Commonwealth Edison Company

Subject: Supplement No. V to Zion Nuclear Power
Station Environmental Report - AEC Dkts
50-295 and 50-304

Commonwealth Edison Company submits Supplement No. V to the Zion Nuclear Power Station Environmental Report. Supplement V is in response to a letter from the AEC dated May 8, 1972 which requested copies of an Industrial Bio-Test report entitled "Preoperational Environmental Monitoring (Thermal) of Lake Michigan Near Zion Station, July 1969-December 1969."

Figure 33

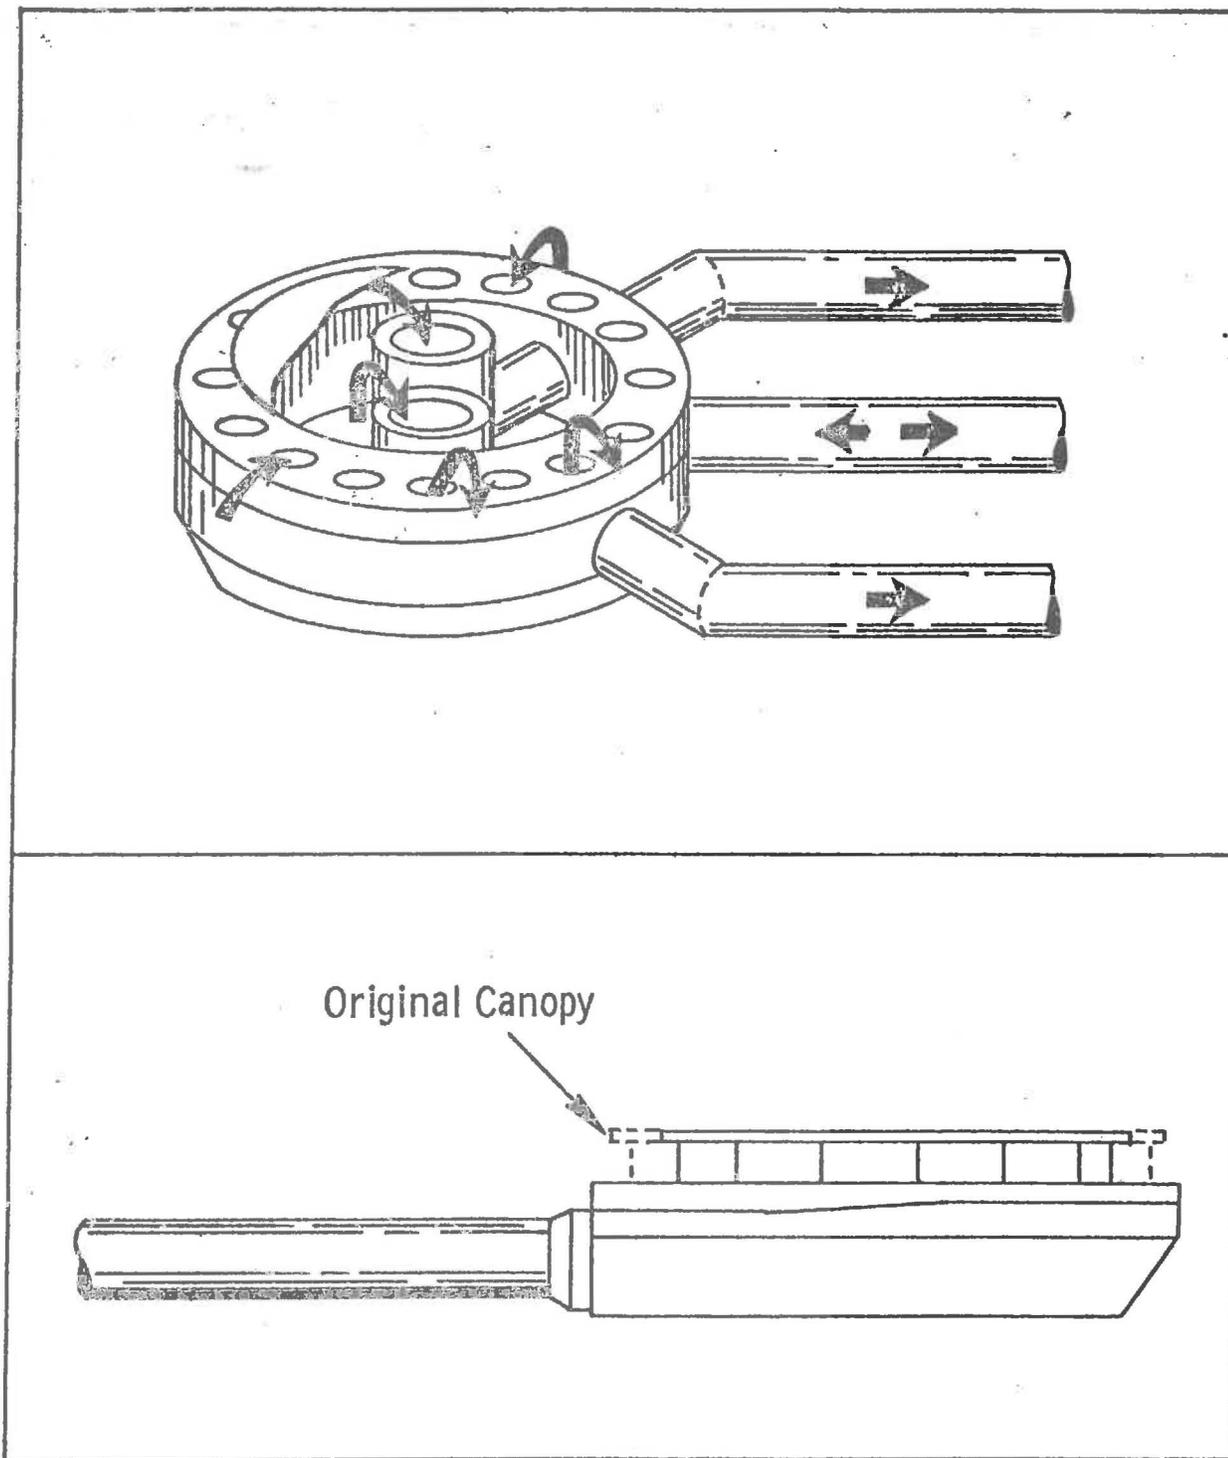
Provide a revised sketch (like Figure 33, page 2.3.6-85 of your Environmental Report) of the intake structure, showing the new canopy roof design. Include any changes that have been made to drawing B-837, Intake Structure (answer to question 10.6, Amendment 16).

Attached is a revised sketch of Figure 33, page 2.3.6-85 of the Environmental Report. The diameter of the intake canopy has been reduced as shown on drawing B-837.

CIRCULATING WATER
AT TRAVELING SCREENS
STATION UNIT 1&2
COMMONWEALTH EDISON CO.
CHICAGO, ILLINOIS
DRAWN D. SINNEN 2-14-72 FIG. C-4-1

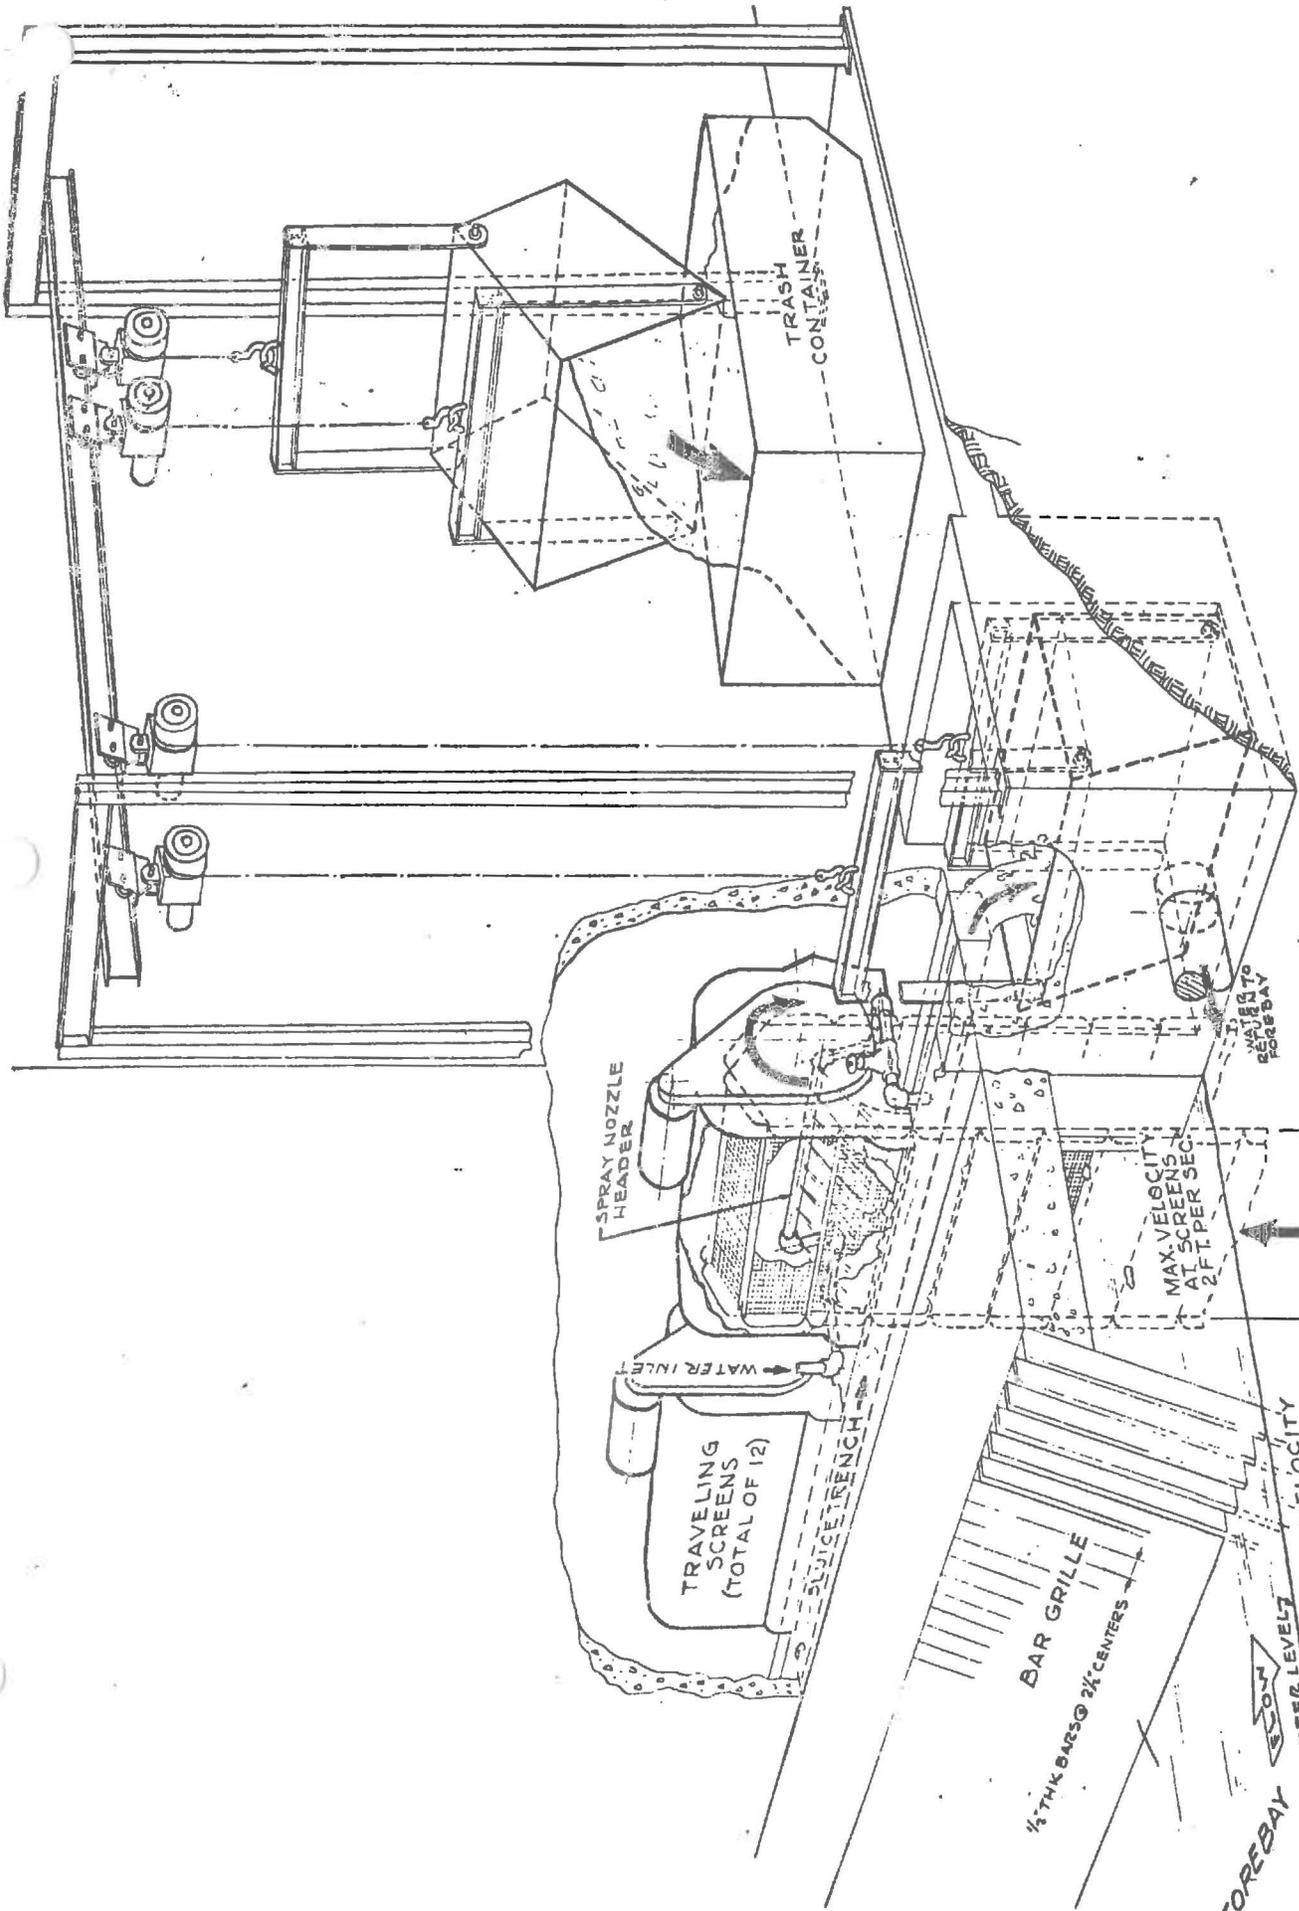
Provide dimensions and water velocities for the bar rack and traveling screens. Provide the vertical speed of the traveling screens. Provide a sketch of the traveling screens, including the clearing of debris from the shelves as they move over the top.

Attached is Fig. C-4.1 of the traveling screens showing the method of debris removal. There are twelve (12) traveling screens, six (6) for each Unit. The velocity of the water through the screens varies from a maximum of 2.0 ft/sec. at low operating water level to 1.4 ft/sec. at high operating water level. The velocity through the bar grill varies from a maximum of 1.2 ft/sec. at low operating water level to .8 ft/sec. at high operating water level. These velocities are for six (6) circulating water pumps operating and four (4) service water pumps operating. The vertical speed of the traveling screen is 10 ft/min. The width of each screen is 10'-0" while the width of each unit is 11'-2". At high operating water level, the depth of the water at the screens is 26'-5" and at low operating water level, the depth of the water at the screens is 19'-0".

TRITIUM RELEASE RATE - ZION UNITS 182

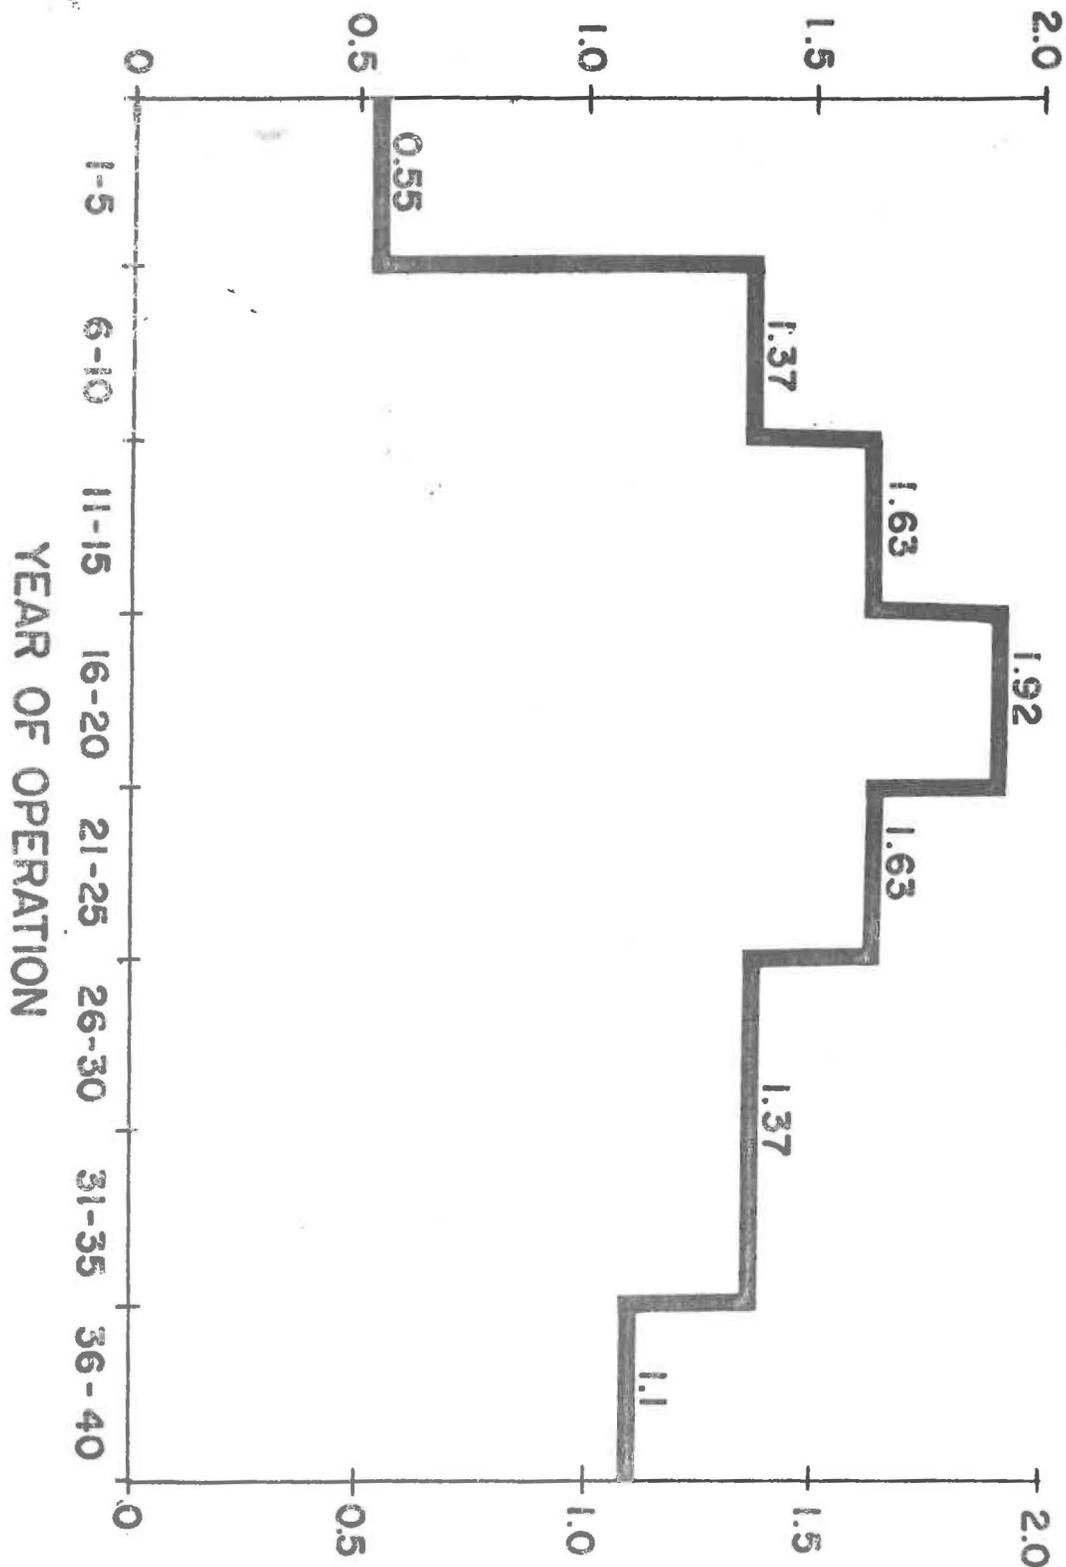
Provide changes (if any) in the anticipated radioactive emissions as described in Supplement I to the Zion Station Environmental Report (November 1971).

The expected emissions for tritium have been revised to account for the gradual build up of the plant tritium inventory. The attached table (Fig. D-3.1) indicates the daily average microcurie release during any five (5) year operating period of Zion Units 1 & 2. These emissions take into account the recycle of approximately 70% of the tritiated water, normal decay of tritium and the anticipated capacity factors of the units.
